**World Forum for Harmonization of Vehicle Regulations****Working Party on Noise and Tyres****Seventy-ninth session**

**Tyres: UN Regulation No. 117 (Tyre rolling resistance, rolling noise and wet grip)****Proposal for Supplement 2 to the 03 series of amendments to  
UN Regulation No. 117****Submitted by the experts from the European Tyre and Rim Technical  
Organization\***

Figure 1  
**Nomenclature explanation related to grip index of the tyre**

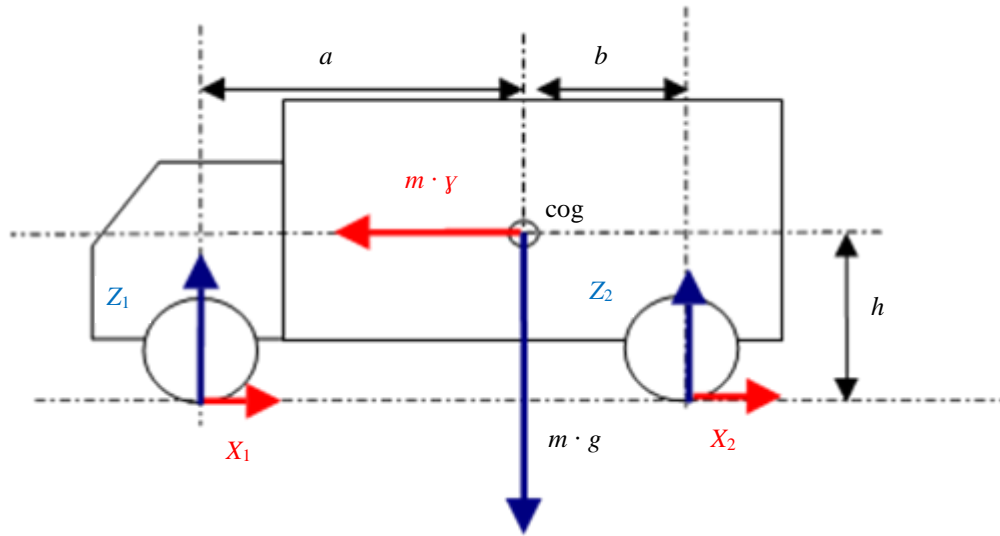
Paragraph 2.2.2.7.5., amend to read:

The wet grip index represents the relative performance of the candidate tyre compared to the reference tyre. The way to obtain it depends on the test configuration as defined in paragraph 2.2.2.2. of this Annex. The wet grip index  $G$  of the tyre is calculated as reported into Table 7:

Configuration C1: candidate tyres on both axles	$G = f \cdot \frac{BFC(T)}{BFC(R)}$
Configuration C2: candidate tyres on front axle and reference tyres on rear axle	$G = f \cdot \frac{BFC(T) \cdot [a + b + h \cdot BFC(R)] - a \cdot BFC(R)}{BFC(R) \cdot [b + h \cdot BFC(T)]}$
Configuration C3: reference tyres on front axle and candidate tyres on rear axle	$G = f \cdot \frac{BFC(T) \cdot [-a - b + h \cdot BFC(R)] + b \cdot BFC(R)}{BFC(R) \cdot [-a + h \cdot BFC(T)]}$

<i>For class C2 tyres</i>	
<b>SRTT16C</b>	
$f = 1$	
<i>For class C3 tyres</i>	
<b>SRTT19.5, SRTT22.5</b>	<b>SRTT19.5 siped, SRTT22.5 siped</b>
$f = 1$	$f = 1.04$

Where (see also Figure 1):

**f:** correction factor depending on used SRTT
